**Board of Zoning and Planning
Staff Report
June 27, 2024**

1) Application Number: BZAP-24-14

2) Application Number: BZAP-24-16

3) Application Number: BZAP-24-17

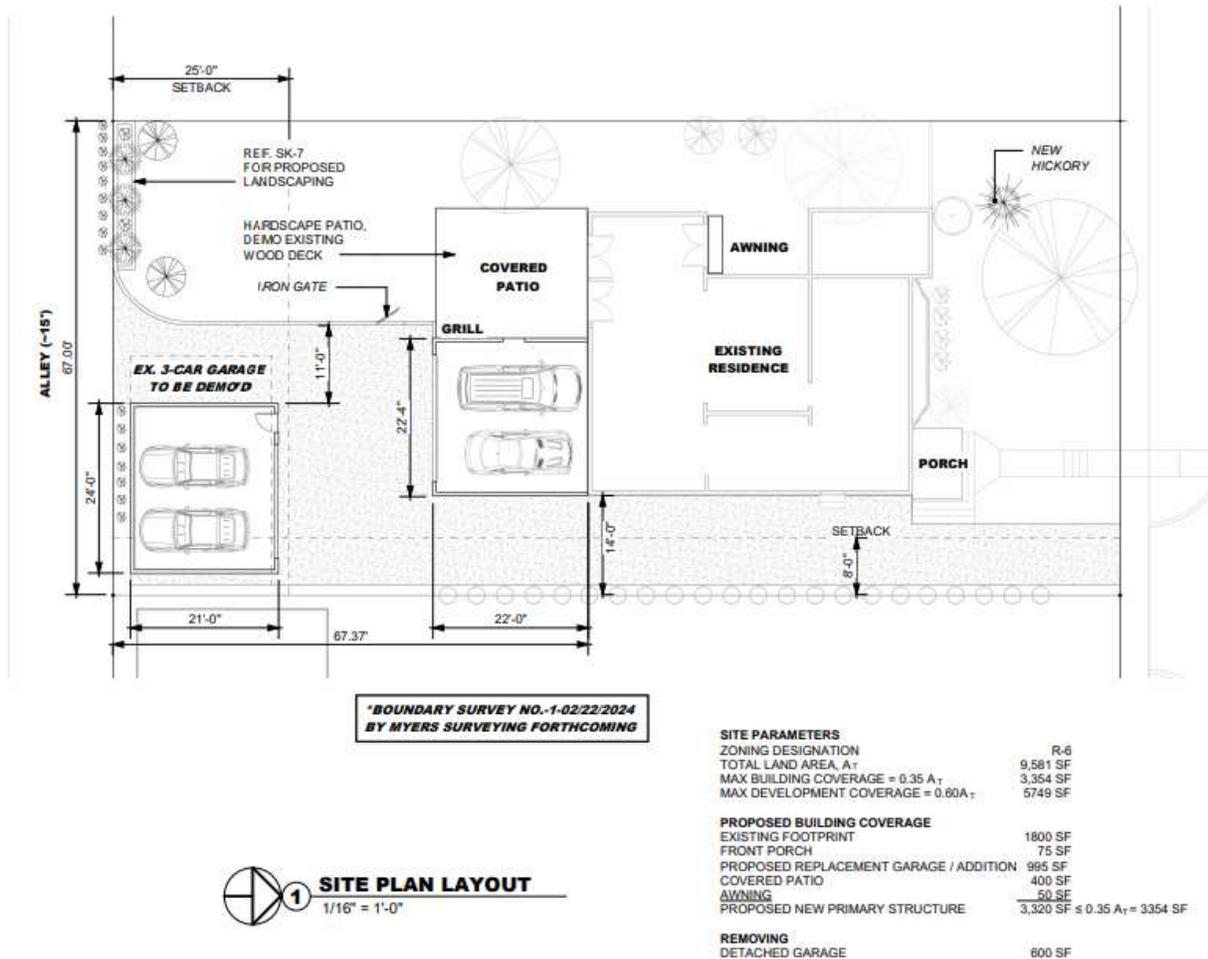
The applicant now proposes a 2-car attached garage to the rear of the principal structure with an attached open porch, which will replace the attached deck. They also propose to replace the existing 3-car detached garage with a 2-car detached garage.

The existing 3-car detached garage is 600sq' with two dormers, and also has a carport type structure attached on the west side

The new 2-car detached garage is 600 sq' feet and will also have dormers, which requires a [Special Permit](#). The eaves are 10' high, which is 1' higher than code permits, which may be supported by the design. Karen can share the design discussion from ARB.

If the Board finds it appropriate to approve a Special Permit for the functional dormers and a 1' variance from Bexley code Section 1252.15(a), to allow the 10' high eaves on the proposed detached garage, staff would defer to the BZAP for any conditions they find necessary in allowing for the replacement structure as proposed.

PROPERTY ADDRESS: 123 CASSADY AVENUE, BEXLEY, OHIO 43209

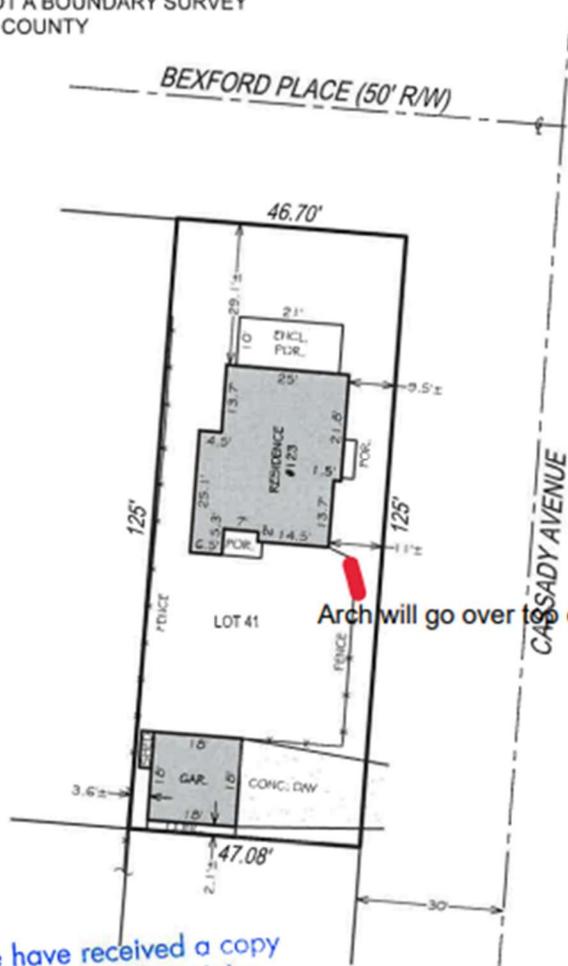
The mortgage survey shows the gate location is approximately 5' back from the (east) side property line along Cassady Avenue. It also shows the right-of-way to be 60'.

The map I have in my office shows this section of the Cassady right-of-way to be 70' in width. This might place the fence on the property line instead of 5' back from the east side property line.

If the Board finds it appropriate to grant a 20' variance from 1252.10(a)(2), to allow the 8' arched trellis over the entry gate at the east side property line, Staff would recommend that the East side property line location be surveyed and verified by the Zoning Officer.

ST. CLAIR MASTERPLAN

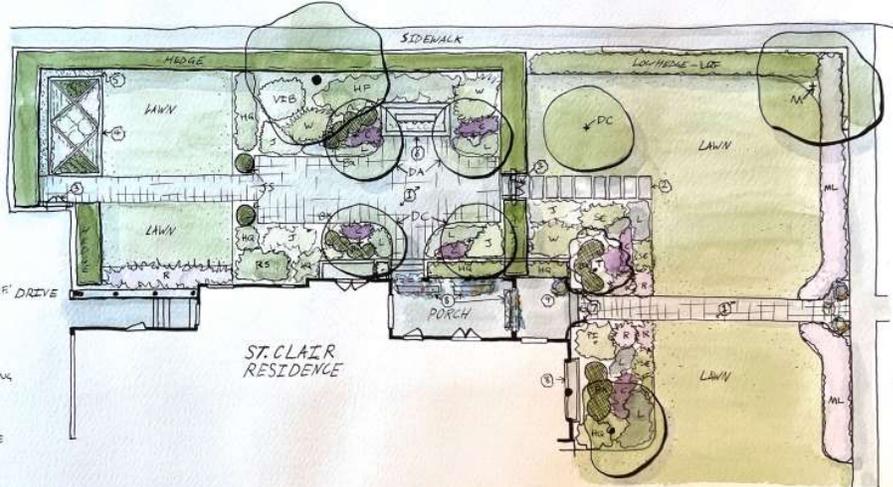
Based on the unusual configuration of the house on the lot, there is little to no rear yard or west side yard. The east side yard is the only location that would accommodate outdoor living space. The owner proposes an enclosed garden space surrounded by a hedge.

The enclosed garden space has doors shown as entry points to the garden and where modified from their original 6' height to meet the 48" height limit for fences in a side yard and within the 25' setback from the side yard property line along Remington Road.

If the Board finds it appropriate to grant a variances from Bexley code Section 1252.15(g)(1) to allow the fountain in the side yard, and from Bexley code Section 1252.10(a)(2) to allow the fountain to encroach 20' into the 25' side yard setback, it should be conditioned upon the review and approval by the City Landscape Consultant on all plantings. The Board may also want to consider a better transition of the hedge proposed at the northeast corner of the property and next to the alley intersecting Remington – to provide safe egress from the alley.

2 FOUNTAIN DETAIL
SCALE 1/2" = 1'-0"

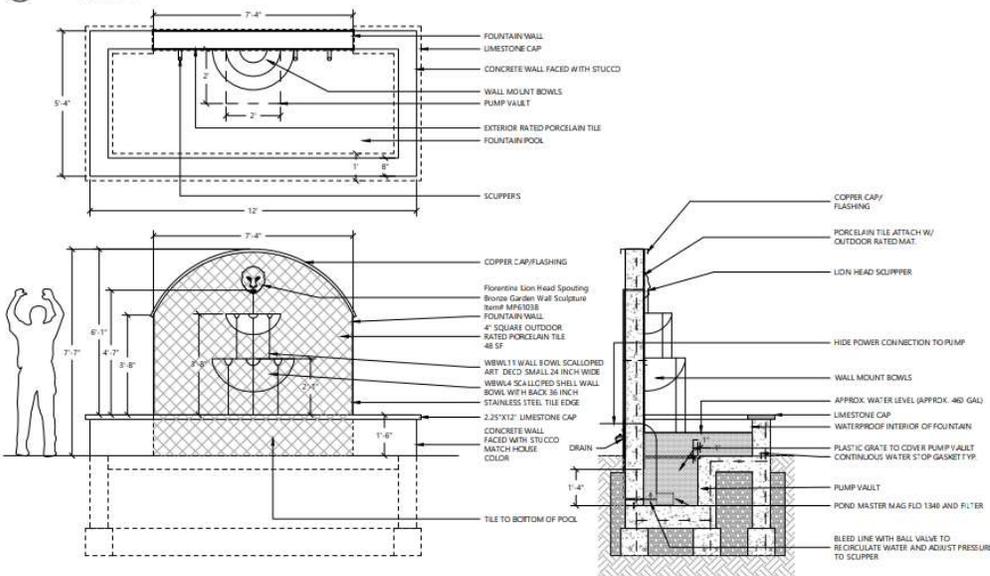
Staff reviewed the work underway at the site and found the start of a concrete structure, which was later indicated to be a proposed water fountain. The location of the fountain is in the side yard and 5' from the east property line.

Accessory structures are limited to 10' in height and are to be located in the rear yard and meet the 3' setback from the side or rear property line. The fact that this is a corner lot requires additional setback requirements. The fountain in 7'7" in height, in the side yard, and located 5' from the east side property line.

This corner lot, and is between 50 to 100 feet in width; therefore, Bexley Code Section 1252.10(a)(2) would require a 25' setback from the street side property line.
